BURLINGTON DEVELOPMENT REVIEW BOARD

Tuesday, September 6, 2022, 5:00 PM

- 1. ZSP-22-7; 52 Institute Road (RCO-RG, Ward 4N) City School Department / Administrative Offices/EED / Joe Weith**
Demolish existing high school and technical center and construct new 268,500 square foot high school and technical center. (Project Manager, Mary O'Neil)

Request: Sketch Plan Review: Demolish existing high school and technical center and construct a new 268,500 square foot high school and technical center.

OVERALL PROPOSED SITE PLAN

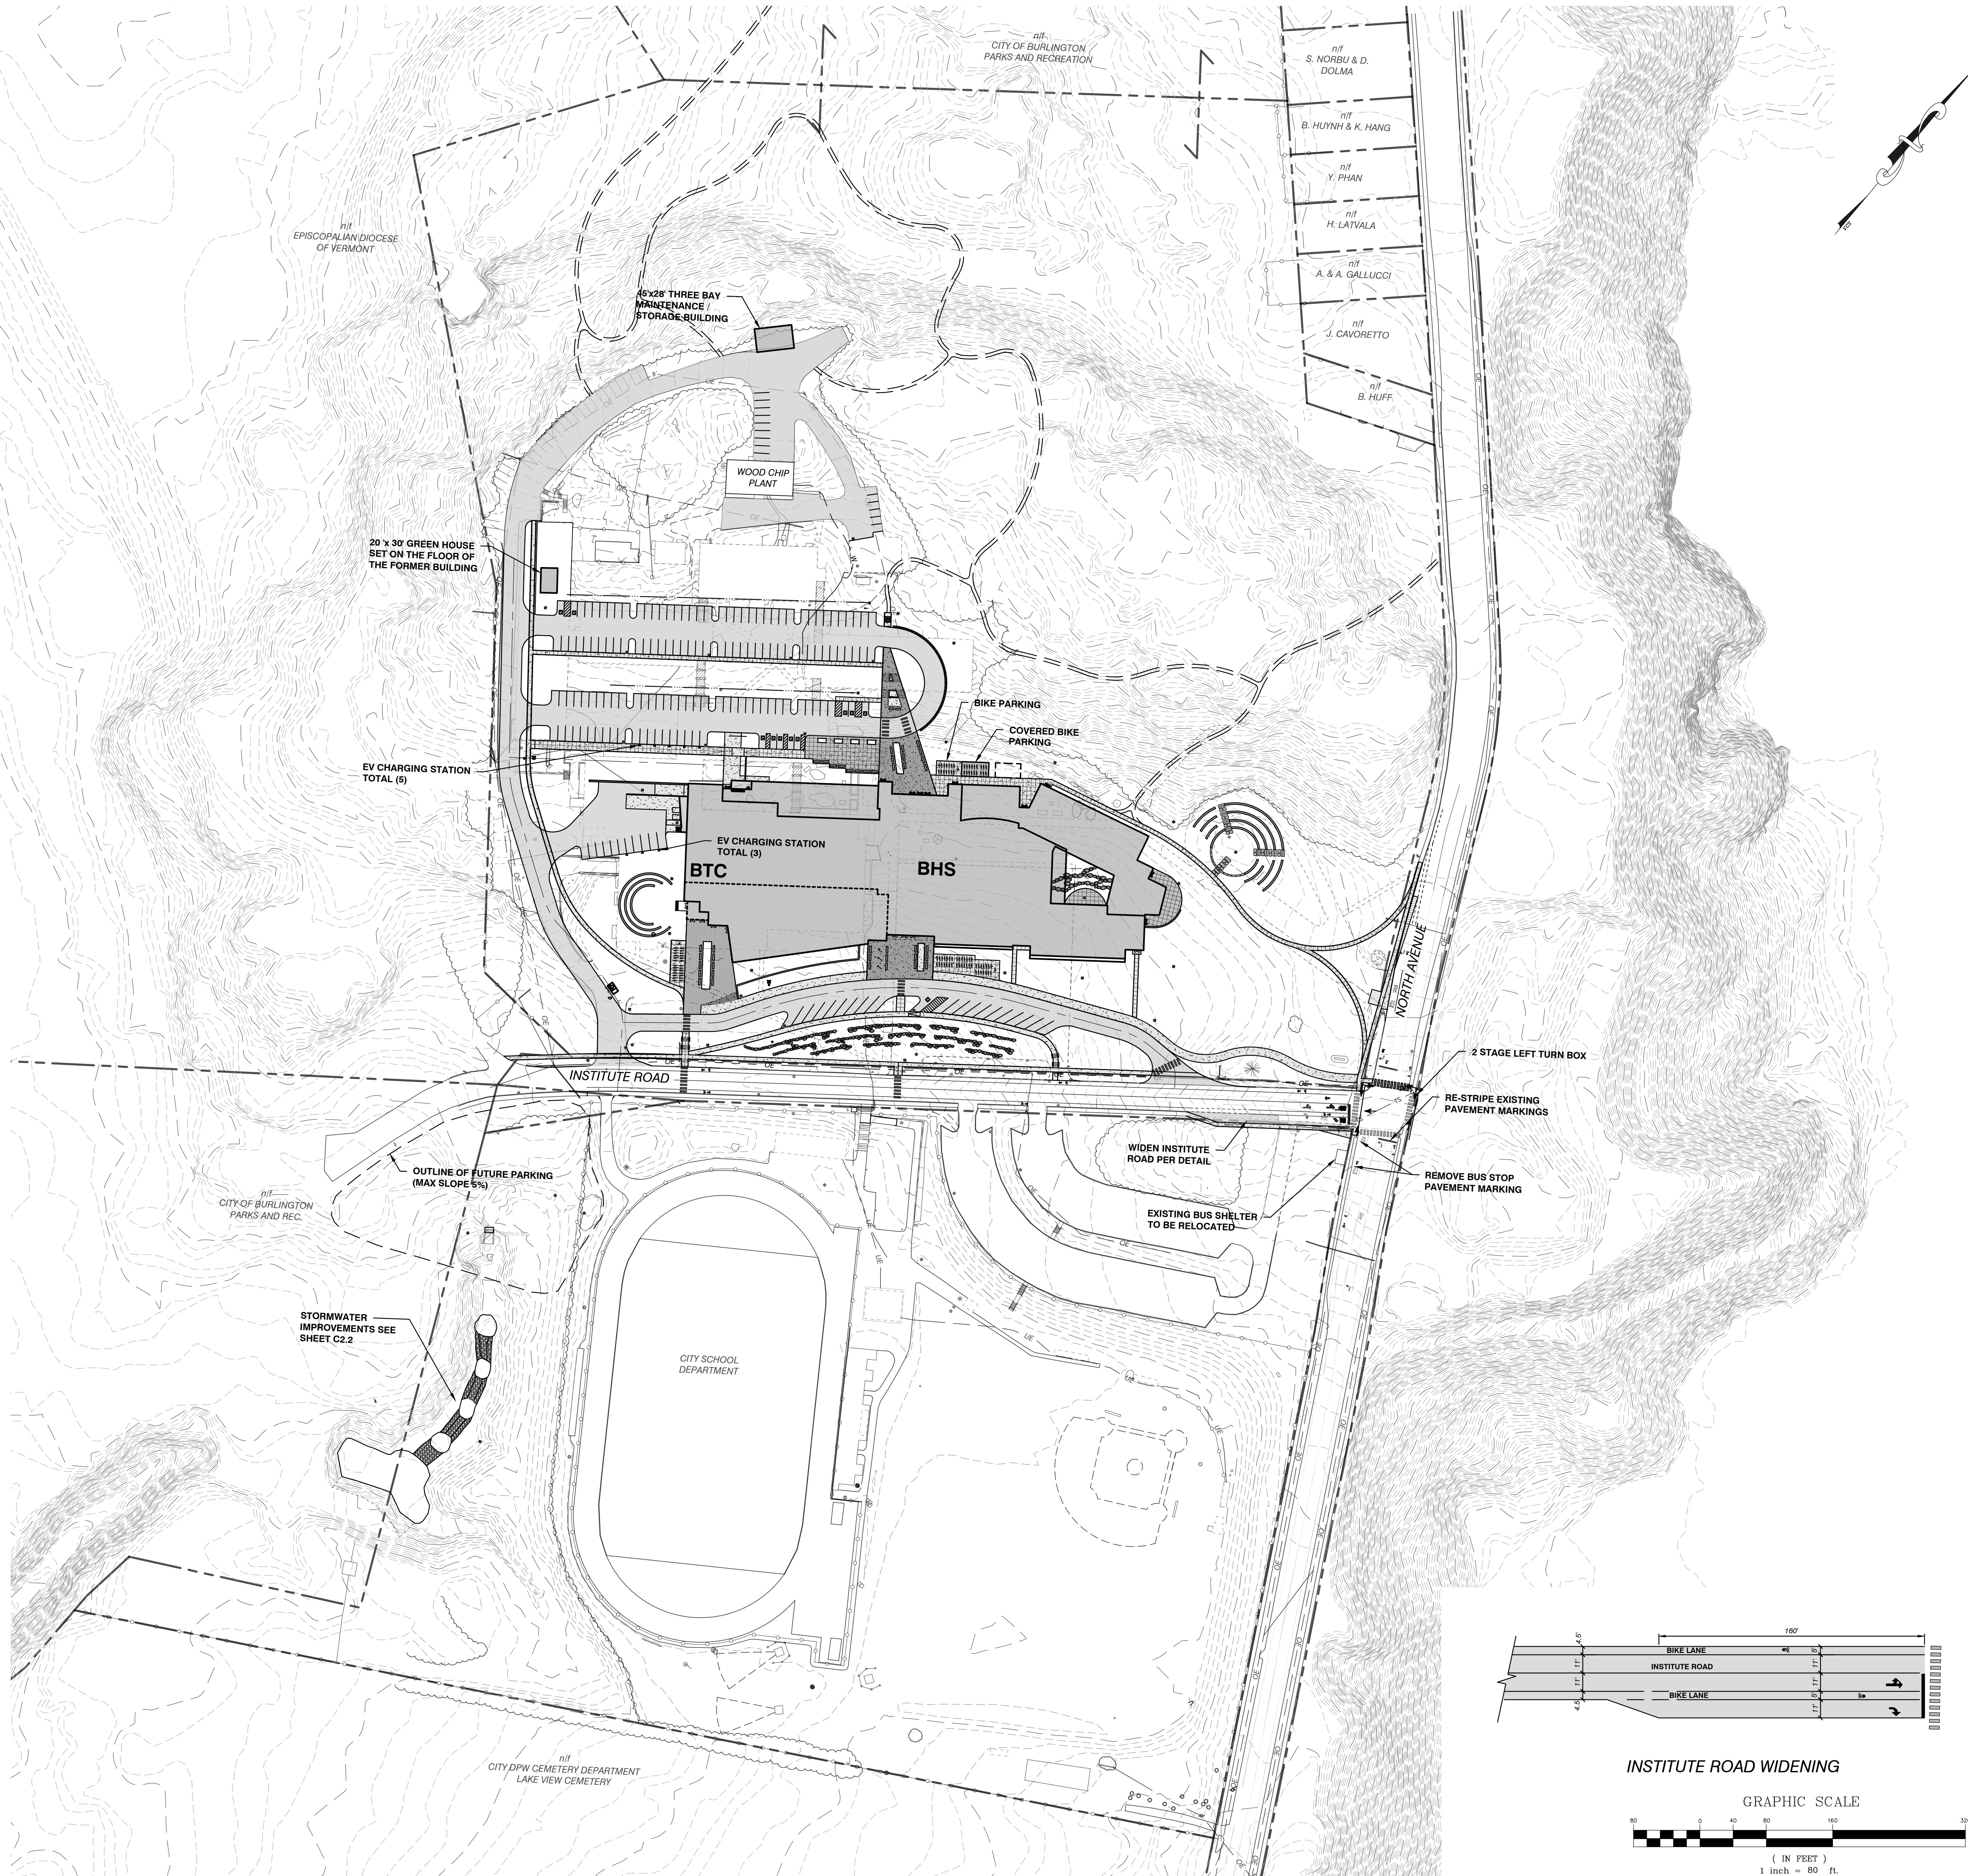
. . Reference is made to Plans C2.0 and C2.1. Of course the existing athletic fields on the south side of Institute Road satisfy the need for active Open Space.

Subsections ii., iii and iv 3. are not applicable for this redevelopment. (c) i. is required; iv. 2 is met. One van space is identified near the BTC entrance (Plan C2.1); however that is likely associated with delivering students to job sites. 5 carpool spaces are illustrated, as well, on Plan C2.1 (north parking area, near entrance plaza.) The applicant's final submission shall define compliance with each standard.

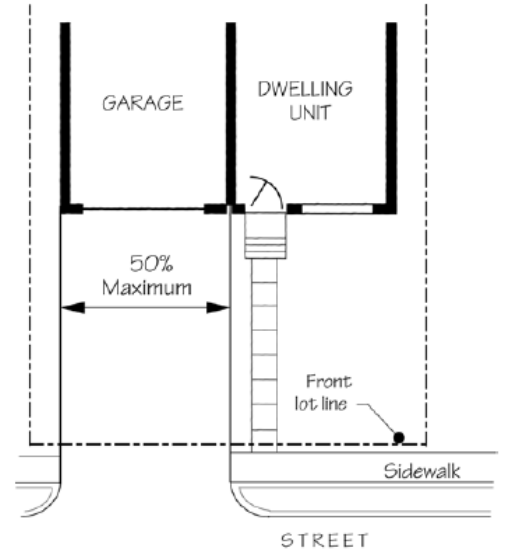
The street-facing wall of the garage constitutes more than 50% of the width of the street-facing façade and living space is required above. But what constitutes ‘above’ here? The upper living space is only connected to the garage via an elevator/stair shaft, with an approximate 22 ft open-air gap between the two. Due to the large gap between the garage and upper living space, compliance with this requirement is questionable. The DRB is requested to make a determination on whether or not the proposed layout meets the intent of this provision. **No finding possible.**
